6029-6031 – Summer 2013 Pavement Rehabilitation

BID ADDENDUM NO. 1

Addition/Change to the Contract Documents

**SW MURDOCK ROAD
PLAN VIEW**

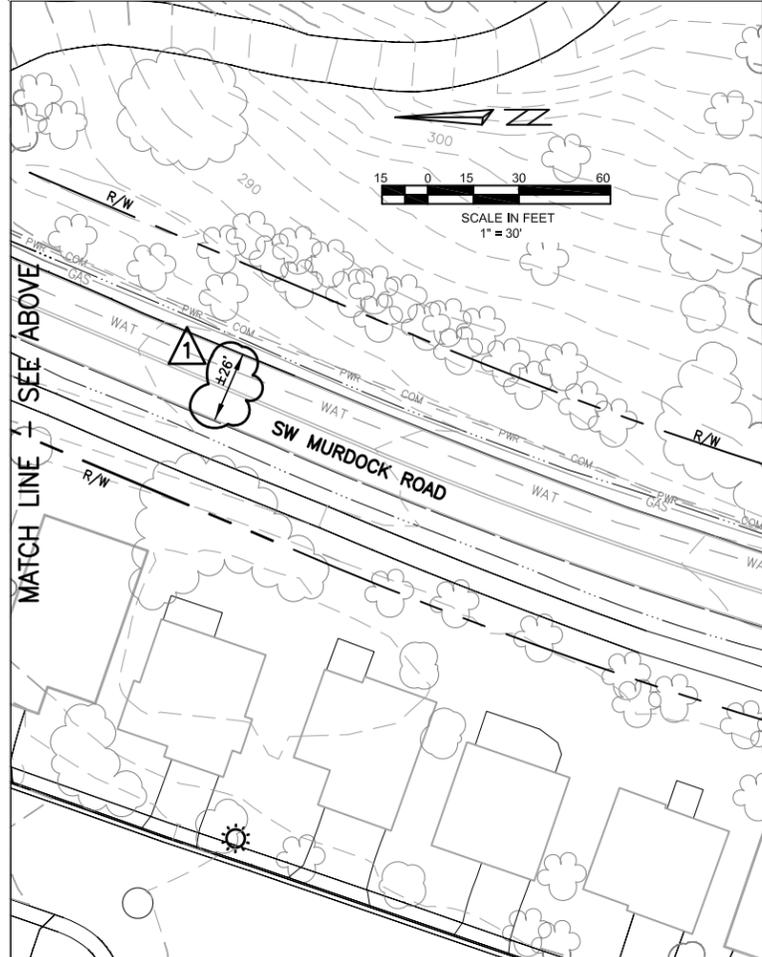
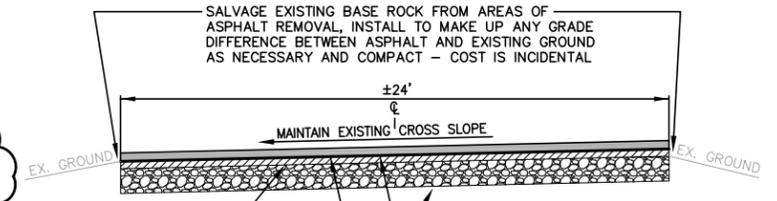
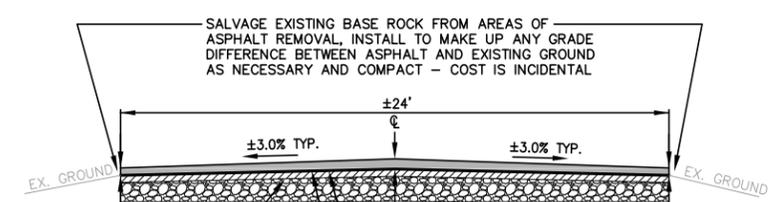
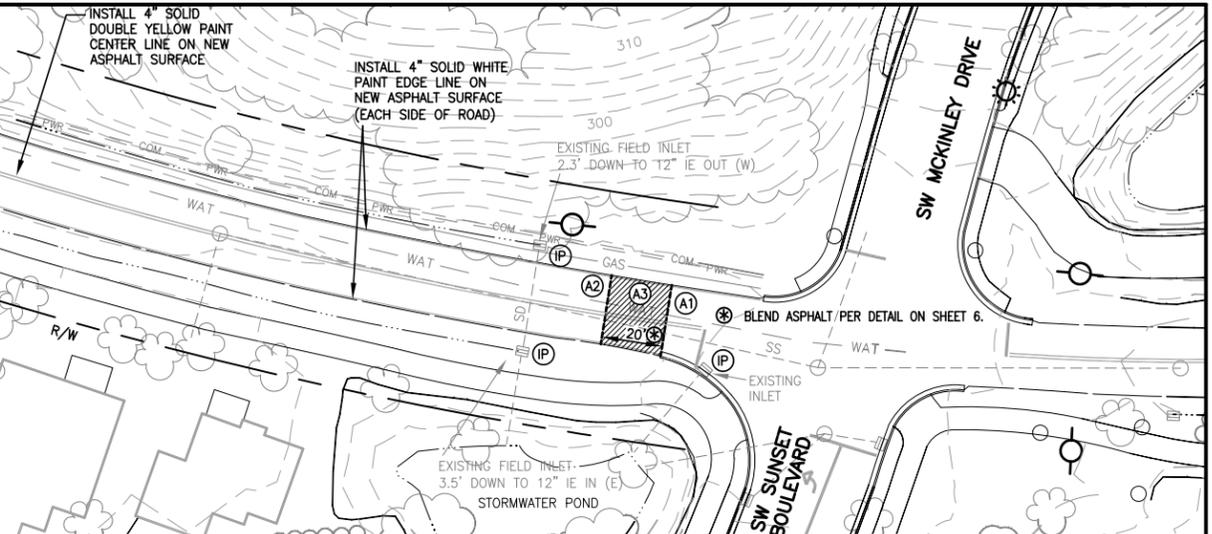
Sheet 3 (attached)

Changed intersection reconstruction to grinding SW Murdock Road in intersection and removing and replacing asphalt in SW Upper Roy Street in intersection.

SW WILDROSE PLACE
PLAN VIEW

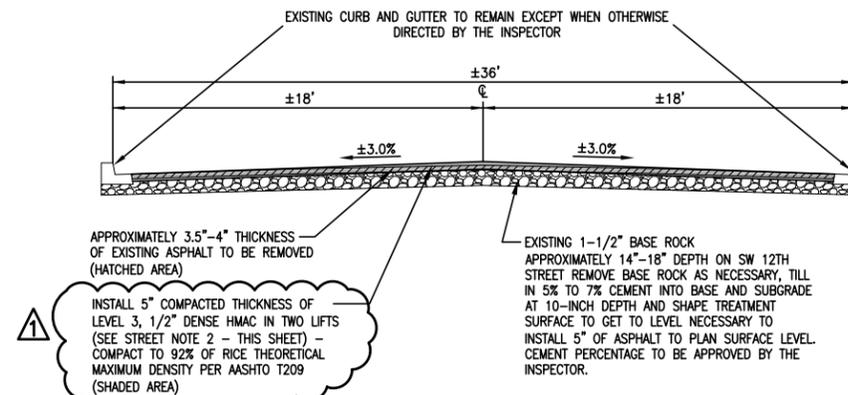
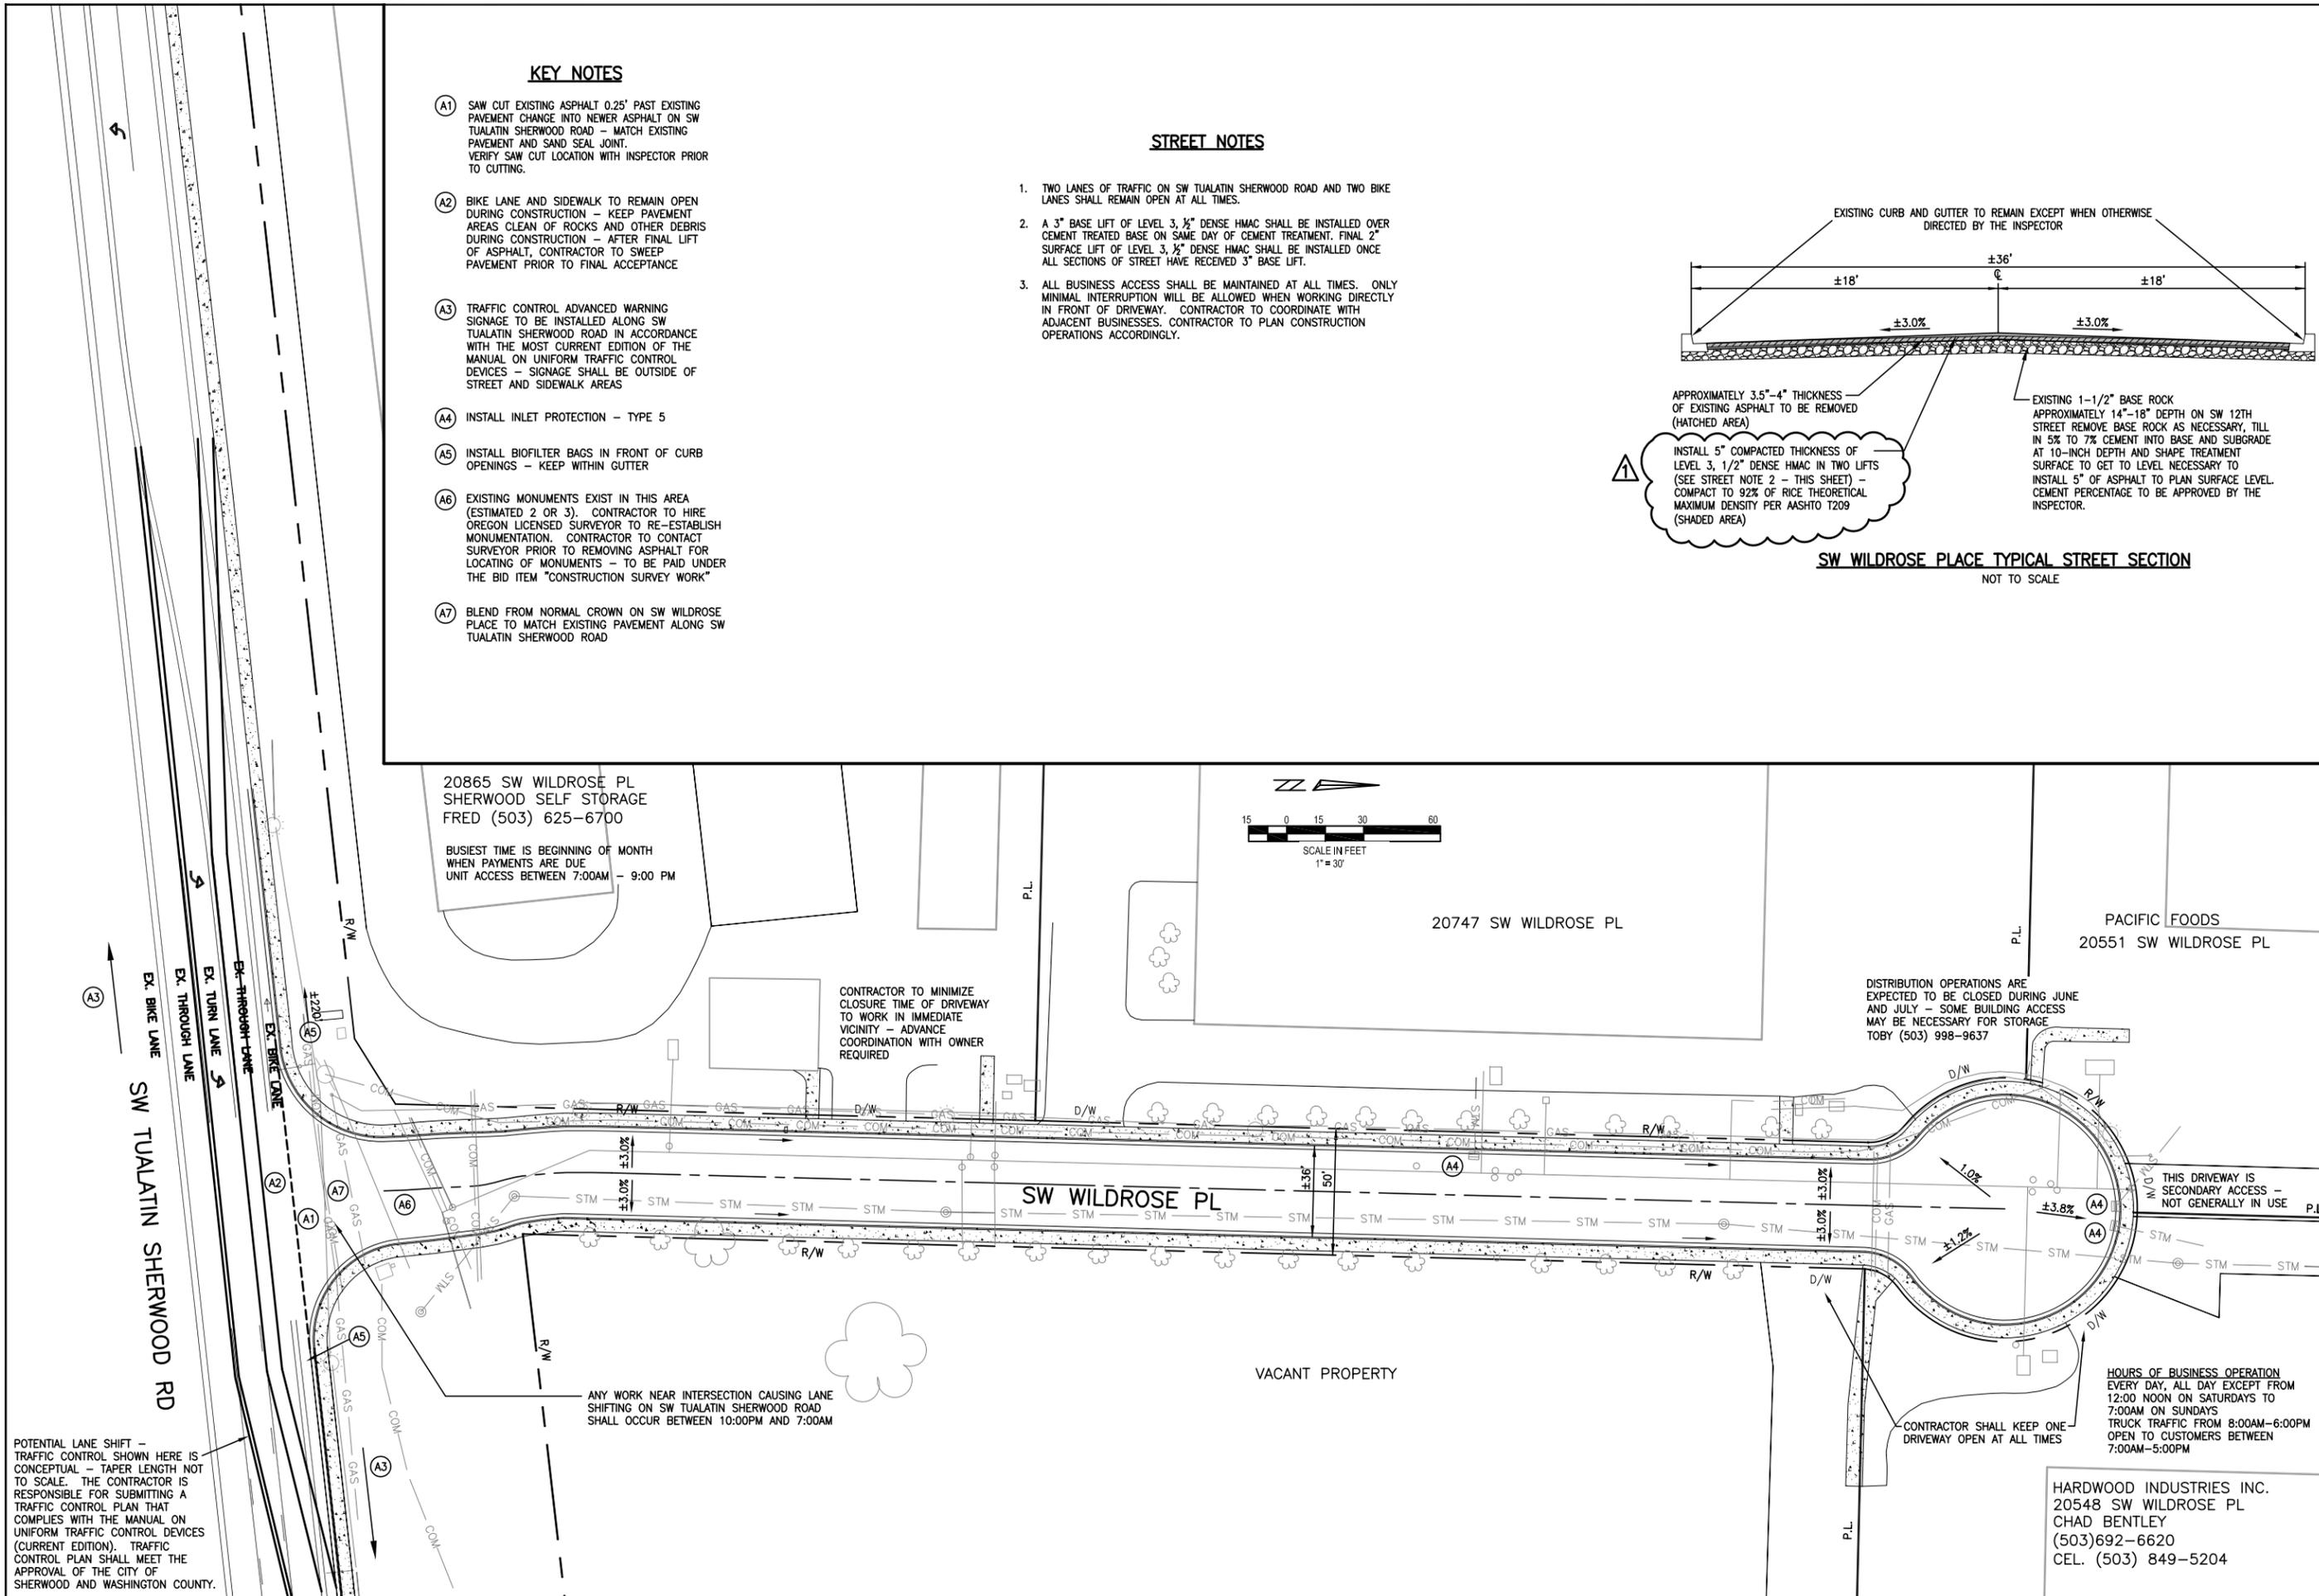
Sheet 4 (attached)

Changed asphalt type on SW Wildrose Place Typical Street Section to Level 3, 1/2" Dense HMA.

SW 12TH STREET
PLAN VIEW

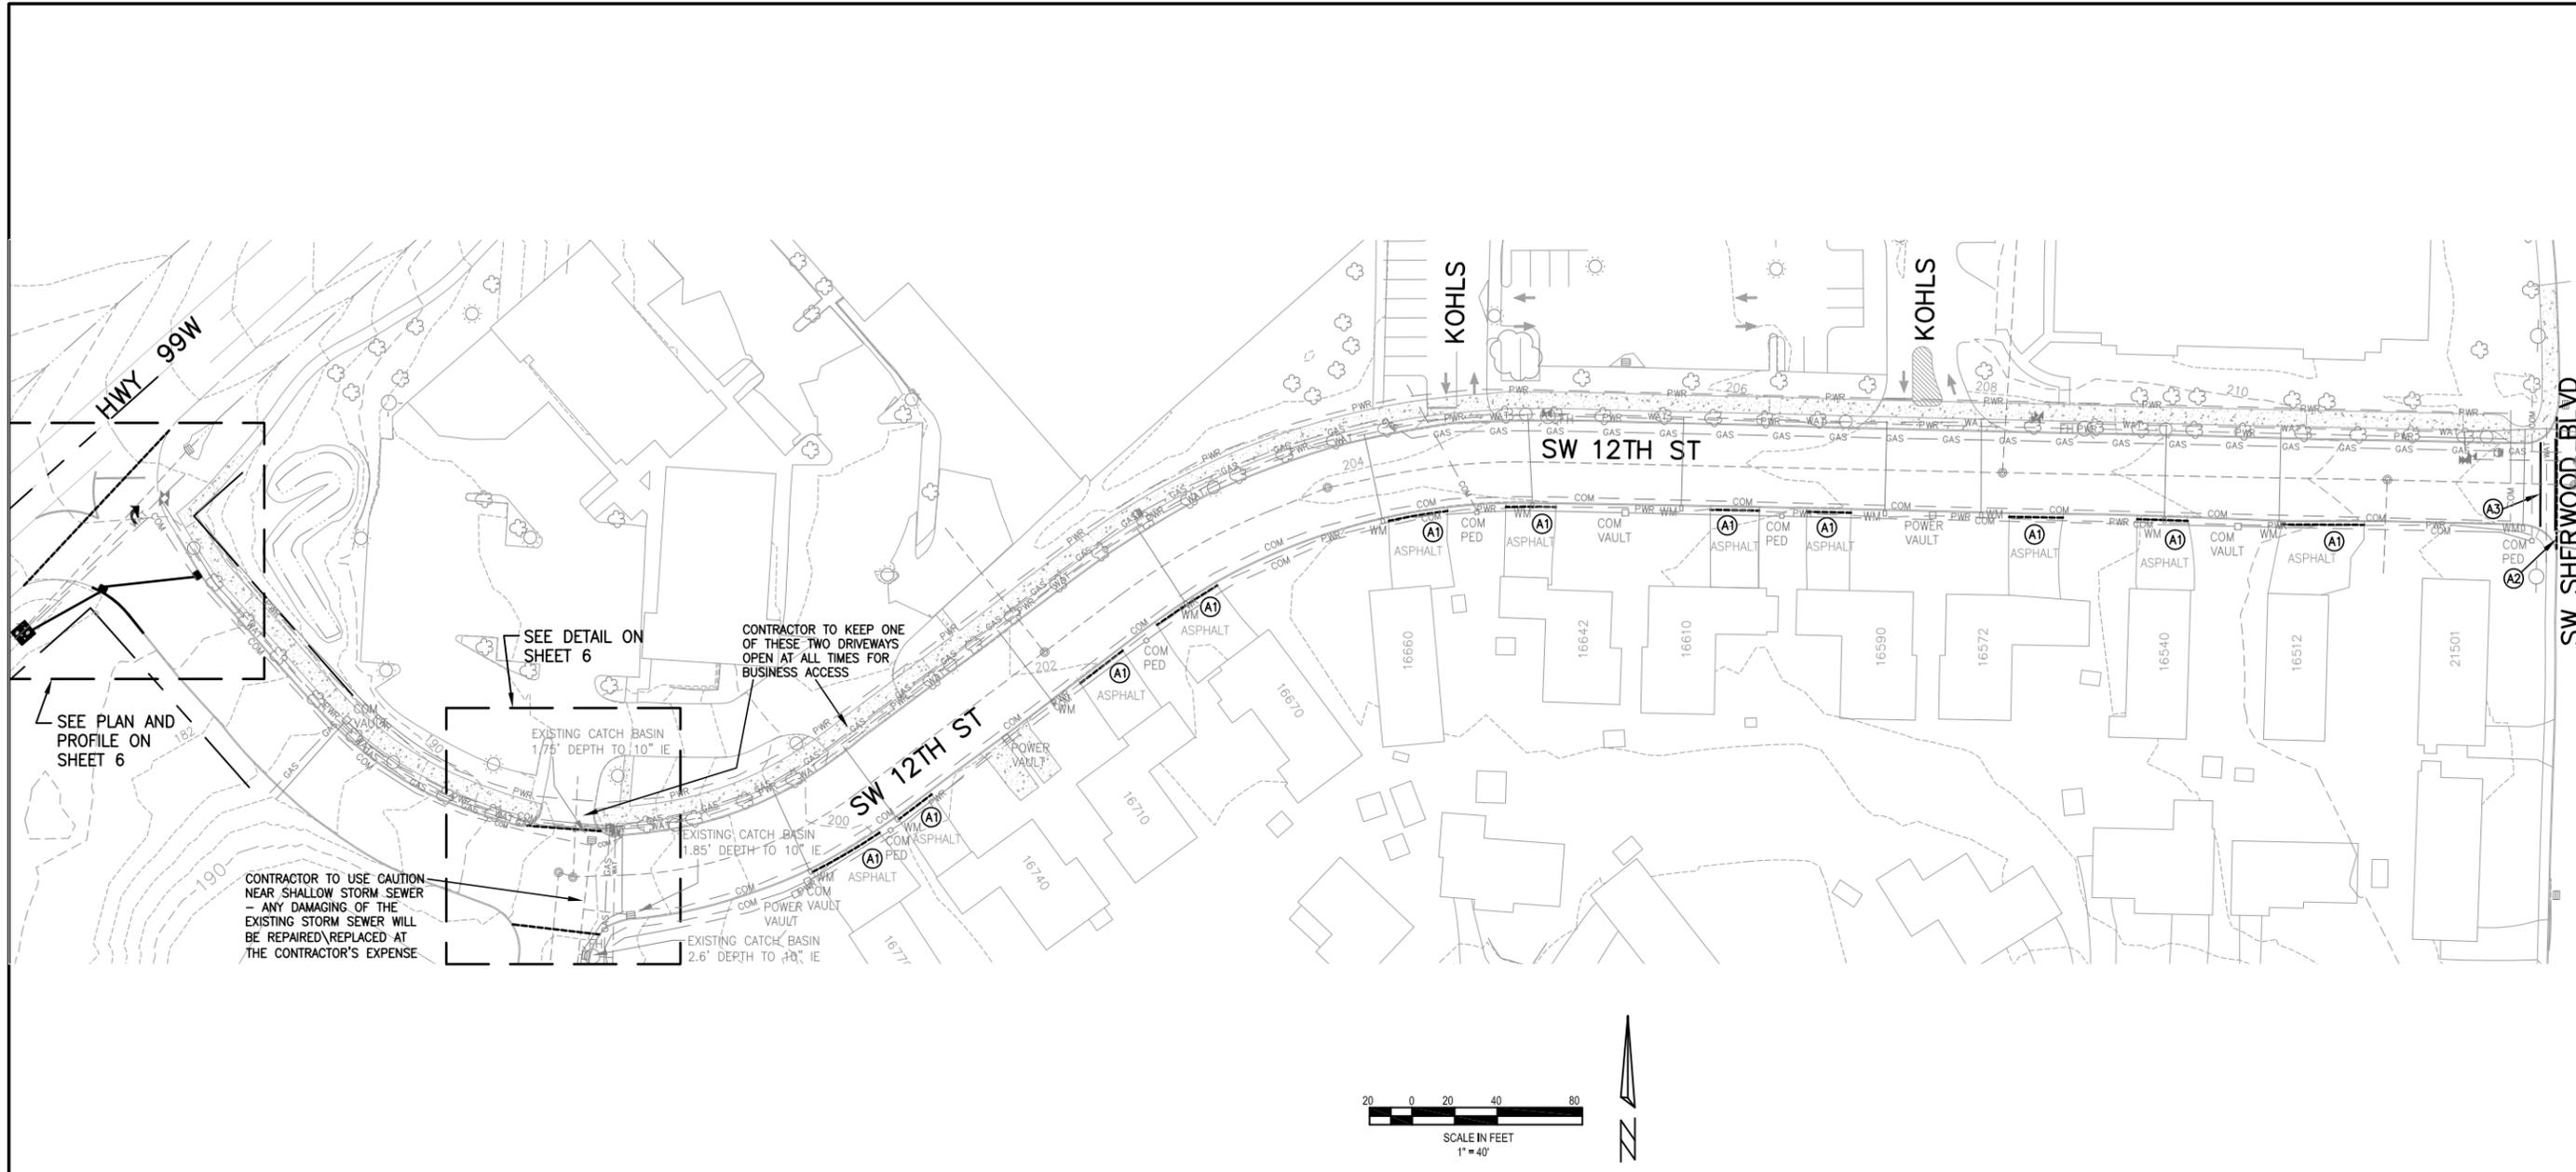
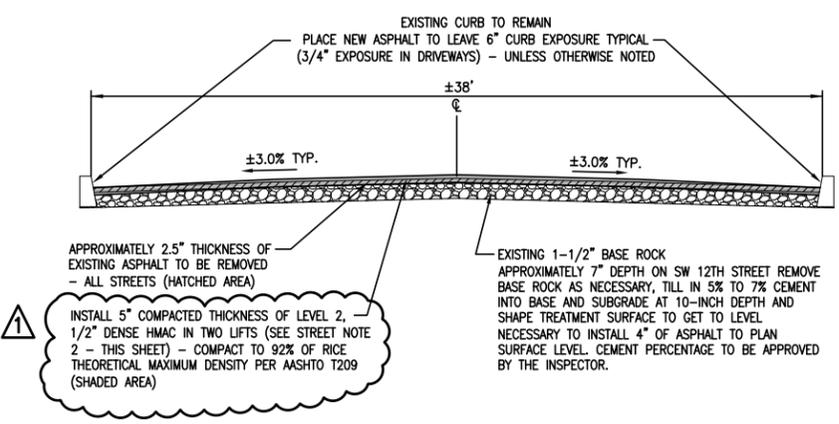
Sheet 5(attached)

Changed asphalt thickness on SW 12th Street Typical Section to 5 inches.

Changed asphalt thickness for asphalt base lift to 3 inches.

AREA DRAIN TYPE II

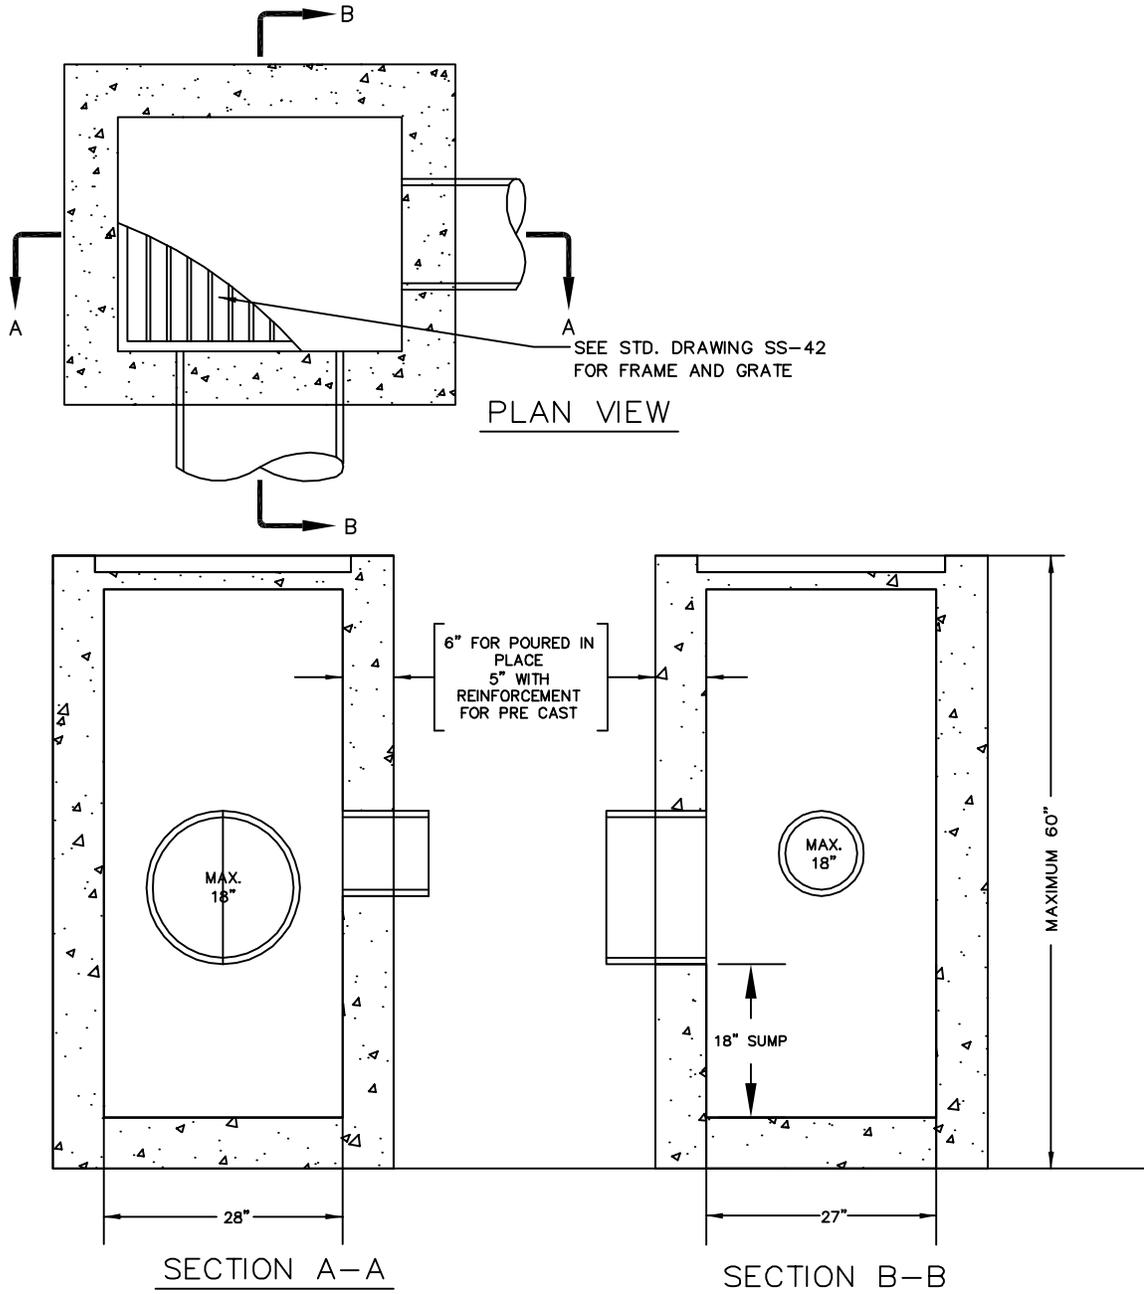
The detail for Bid Item “Area Drain” has been attached to this Addendum.
